PRELIMINARY PLAN
WILGUS TRACT
120200140

RE: Preliminary Plan and Design Exceptions
Preliminary Plan No. 120200140
Wilgus

We have completed our review of the revised preliminary plan uploaded to eplans on April 21, 2020. A previous version of this plan was reviewed by the Development Review Committee (DRC) at its meeting on March 17, 2020. We recommend approval of the plan subject to the following comments:

Cherington Review of Wilgus Preliminary Plan Submission, March 12, 2020

FIRE DEPARTMENT ACCESS OVERALL PLAN

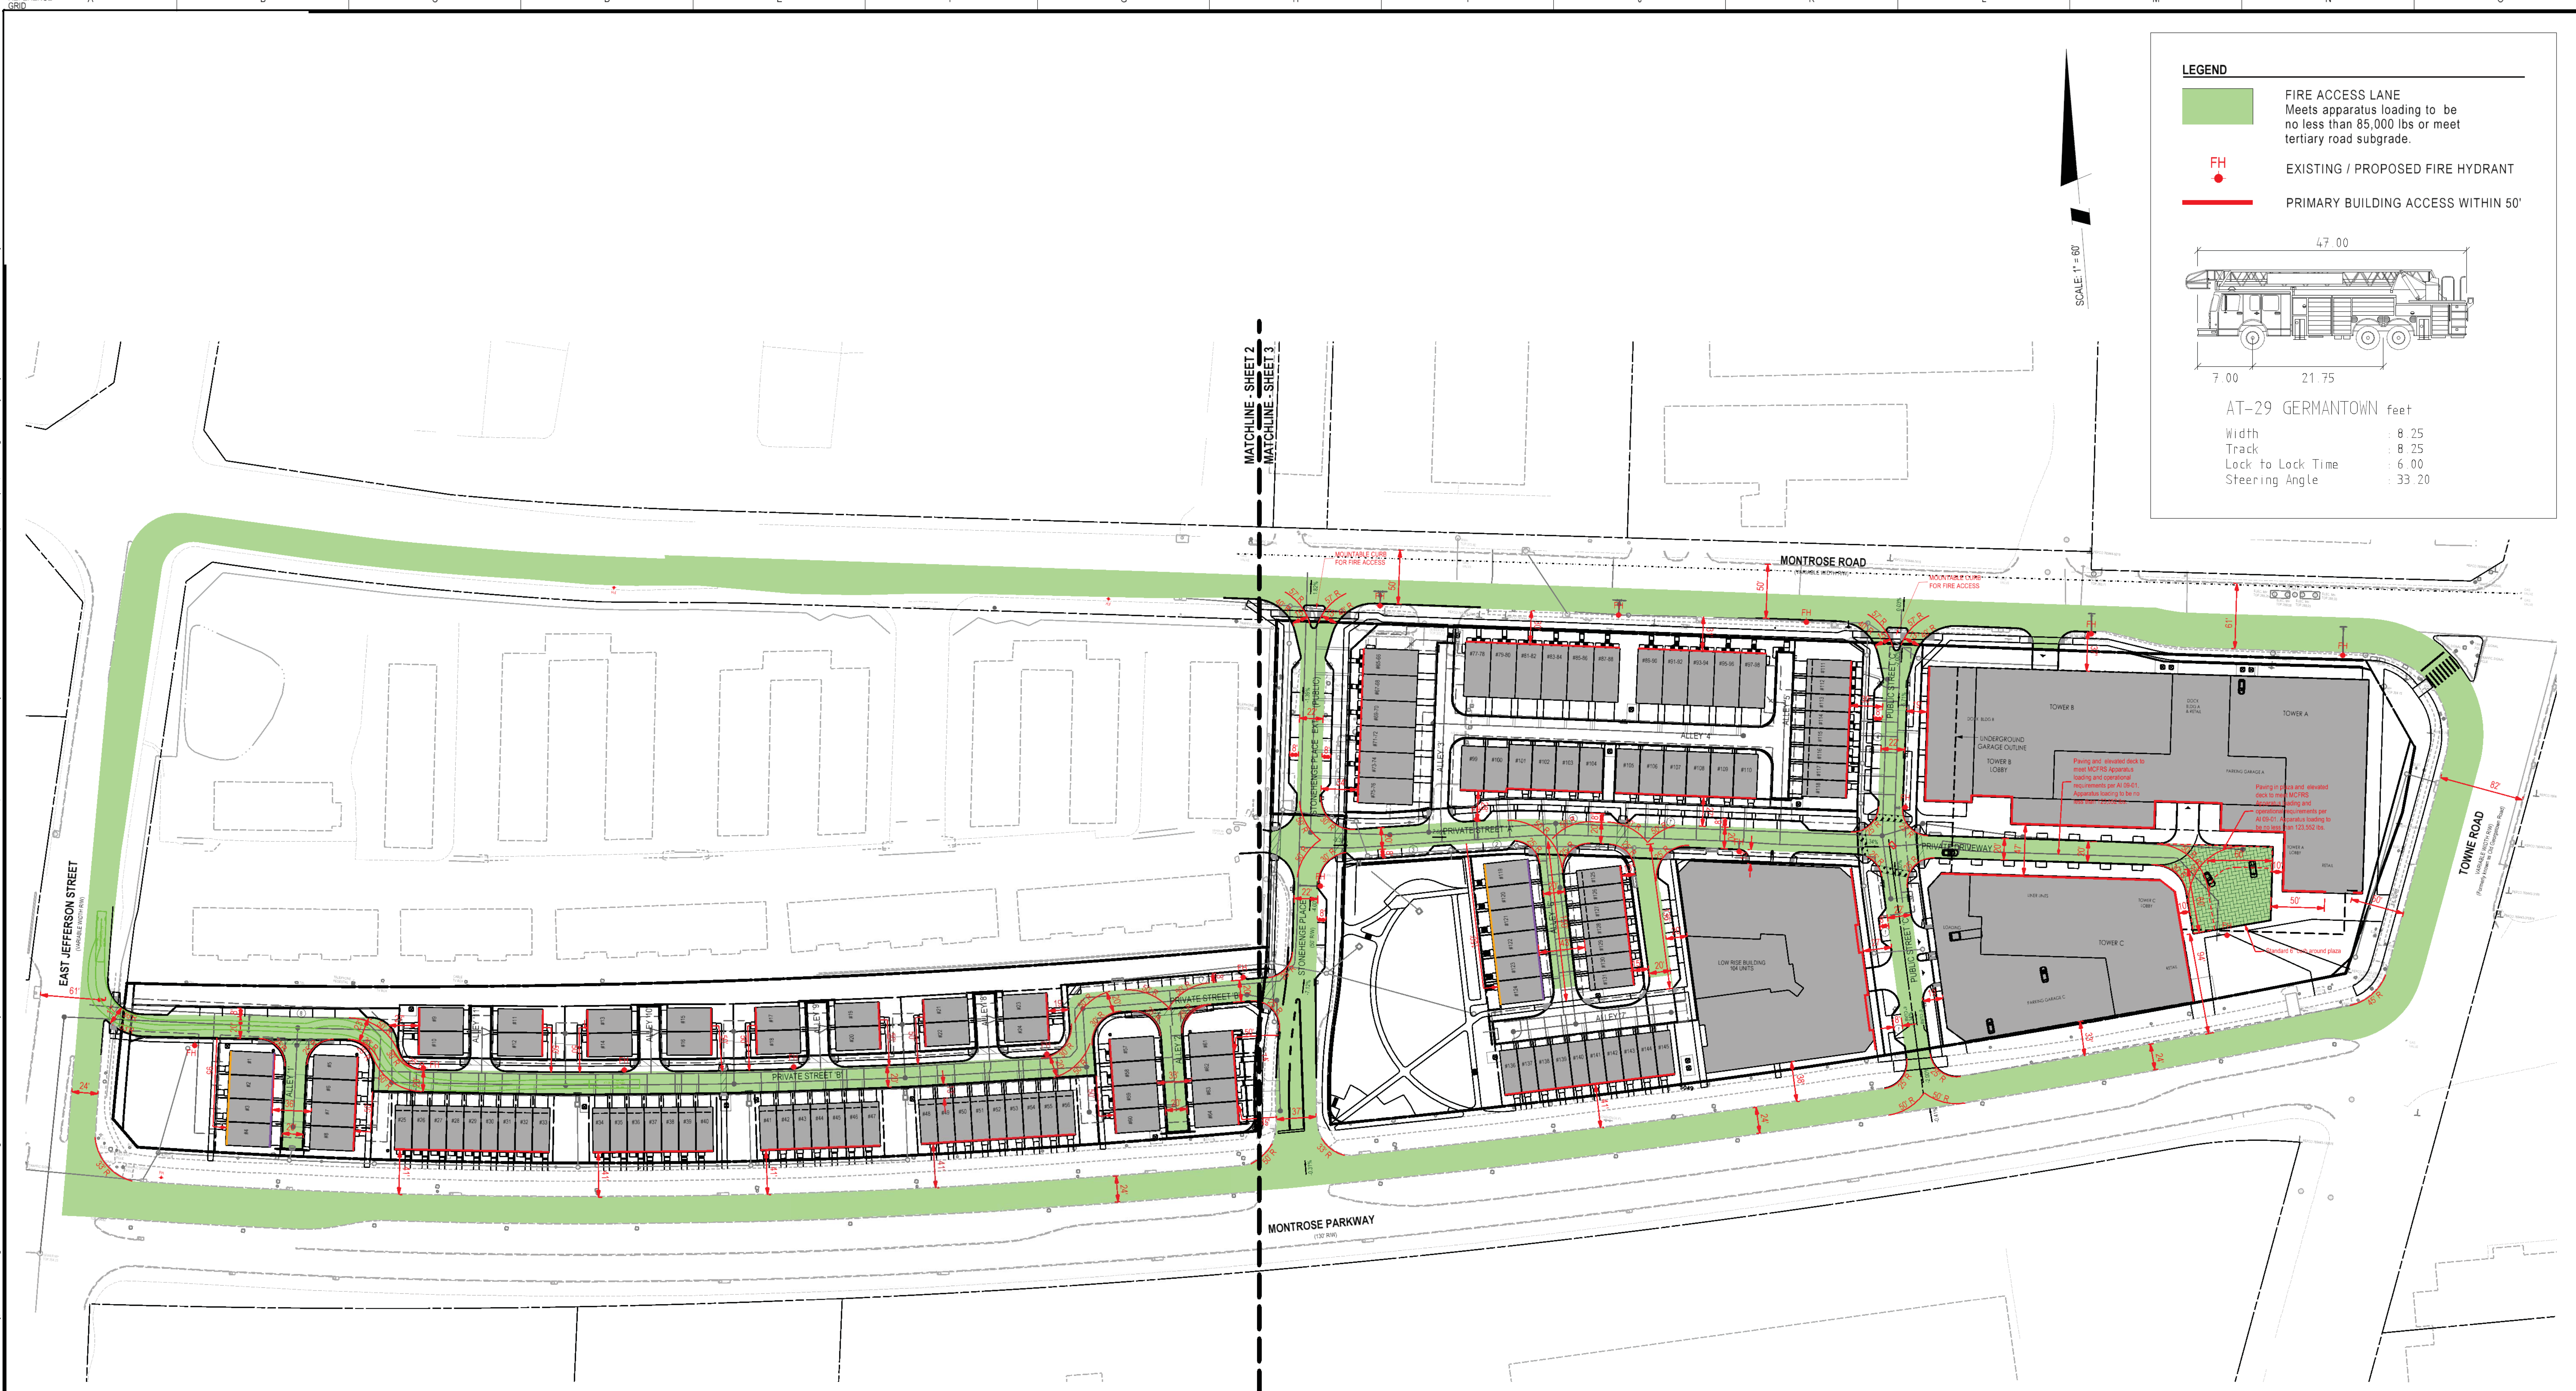
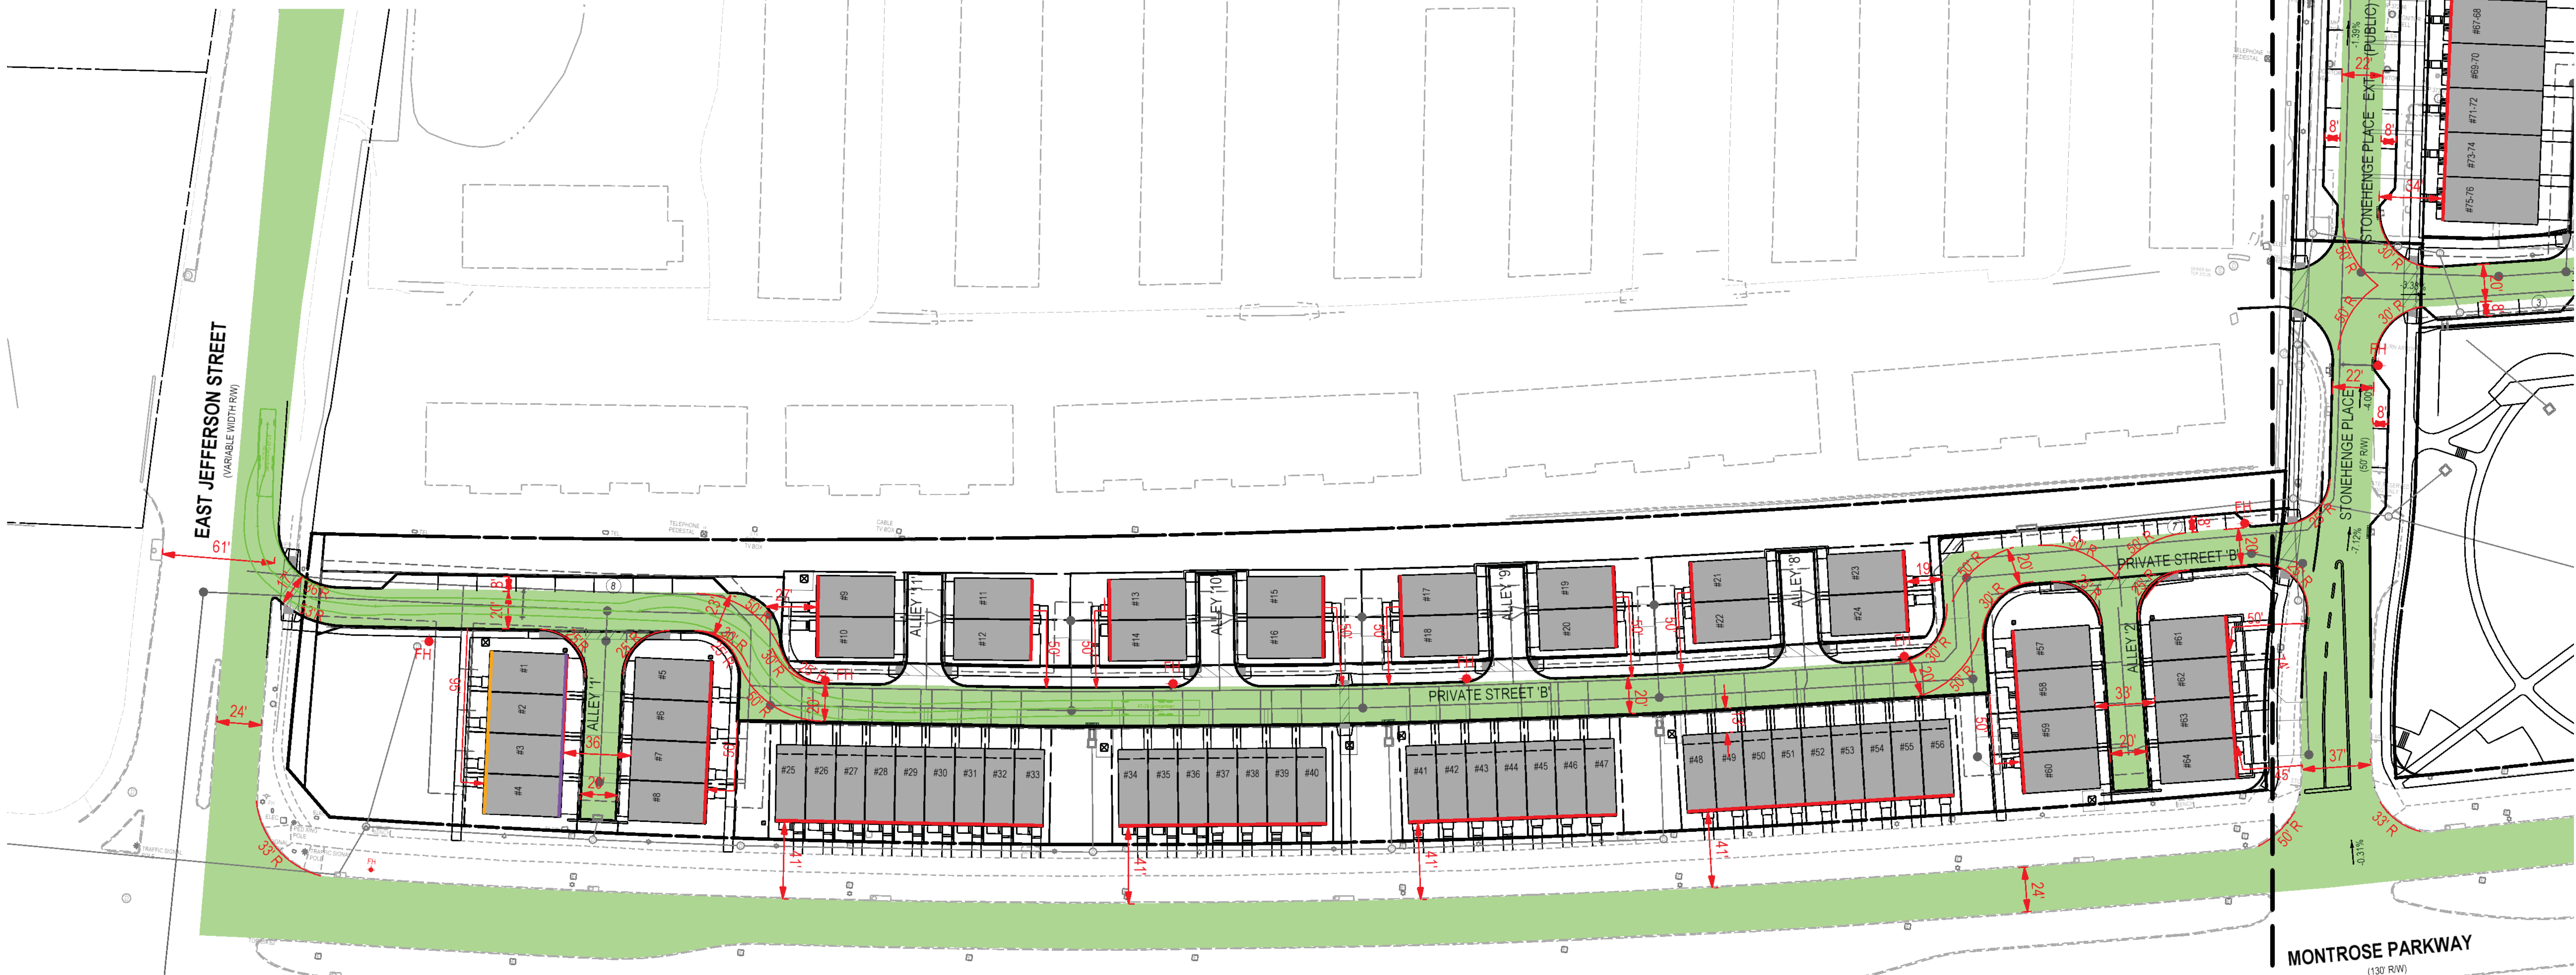
All of the townhomes will have a partial fourth story. For units where the front main side hinge door is more than 50 feet but less than 150 feet from a fire access lane, the fire access plans show an orange band in the front and a purple band in the rear to indicate they are fire height restricted in the front and require secondary rear access within 50' from a fire access lane. These units will provide a 3' side hinge door as a secondary egress on the rear wall of the first story. The rears of these fire restricted units will be permitted to have window sills/dormers above 27 feet, while the fronts of these units will not be permitted sills/dormers, including false dormers above 27 feet.

Since this architectural design provides front height restricted fire fighter access and rear fire department vehicular access, we believe that the performance based design in this case will provide adequate access for fire apparatus.

Cherington Townhouse Community Evergreen Buffer Planting Design

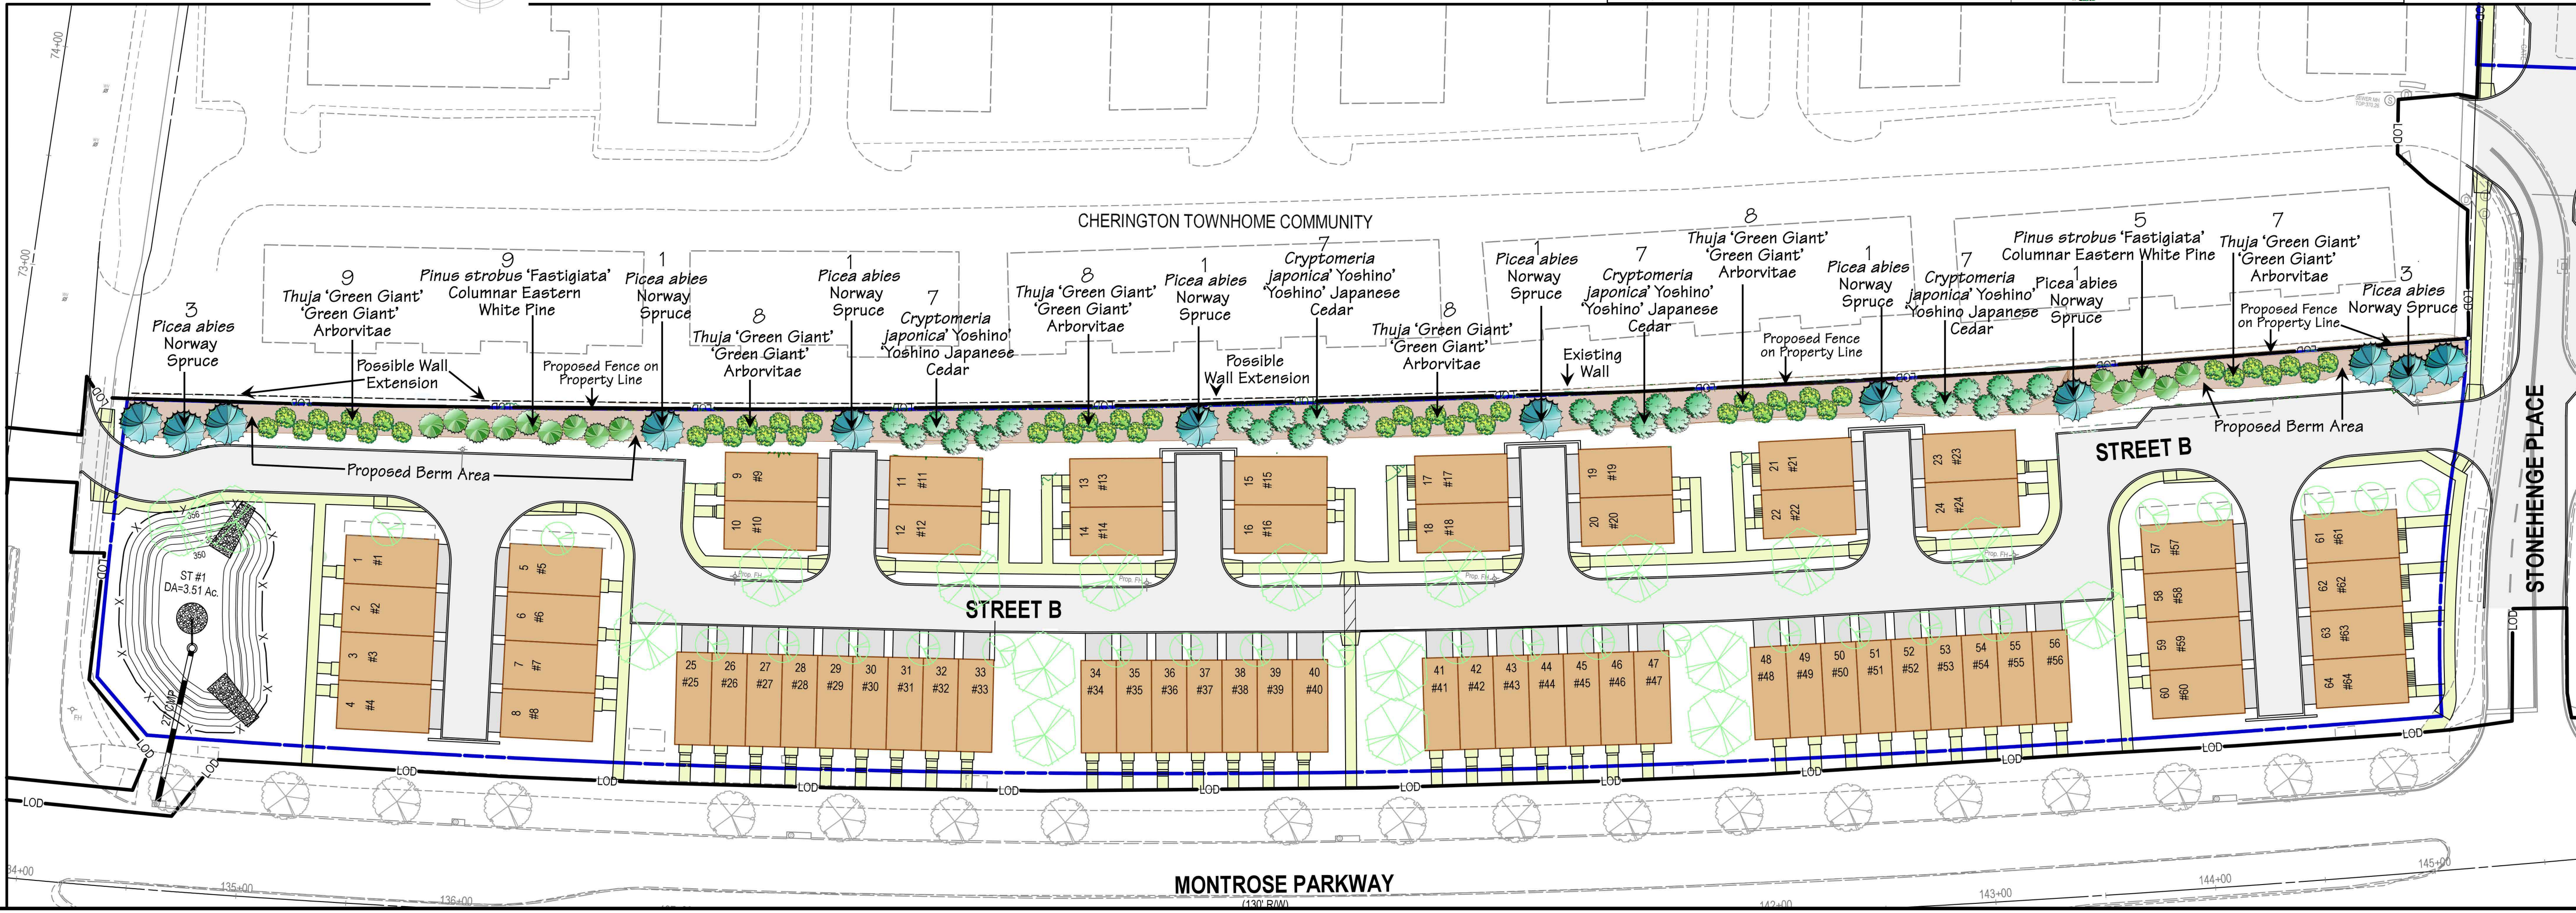
In the attached ‘Cherington Townhouse Community Evergreen Buffer Planting Design’ the tree species and cultivars chosen for the buffer are well-known, readily available in the industry, and will provide the needed screening. They are all upright, conical in shape, and have a variety of textures, shades of green, and scents, for visual and aesthetic enjoyment throughout the seasons. They are arranged in multiple clusters, to provide a rhythm of texture, color and height along the buffer line. They are punctuated intermittently with *Picea abies* (Norway Spruce) for focal points and contrast. Although the buffer zone is narrow (+- 20 feet), the density of the foliage, and the height of the chosen cultivars (30’ - 60’ height) will not only provide a robust four- season evergreen buffer, but create a varied tree line profile, avoiding the appearance of a mono-culture, or unrelenting ‘line of soldiers’. In addition to fulfilling the requirements for screening, light and noise mitigation, this proposed plan and has the added benefit of creating habitat for birds and other wildlife. The plan also requires adequate tree spacing to allow room for robust and healthy growth. The ‘Cherington Townhouse Community Evergreen Buffer Planting Design’ would also create a lovely backdrop for any seasonal flowering small trees and shrubs the Wilgus development plan might like to add in the foreground.

If this buffer is planted on a raised berm (18”-24” high, see attached plan) constructed of excavated material from the site, and well-amended with reserved or additional top soil and compost, the raised planting will more quickly achieve the privacy/buffer goals, and recycle natural materials on site. It will also help control storm water run-off between the communities.

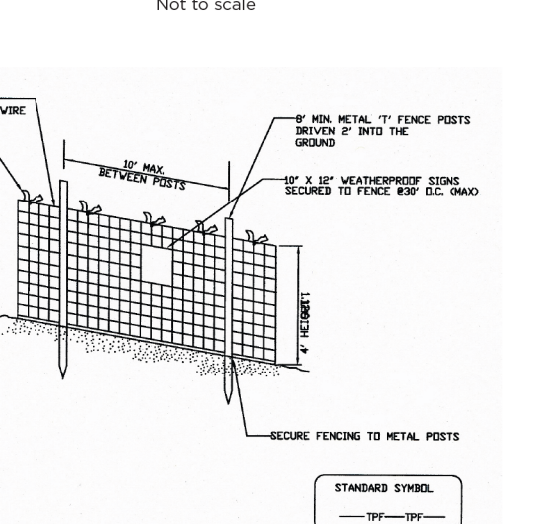
An extension of the existing stone wall should be considered to help control run-off and provide stability for a new berm.
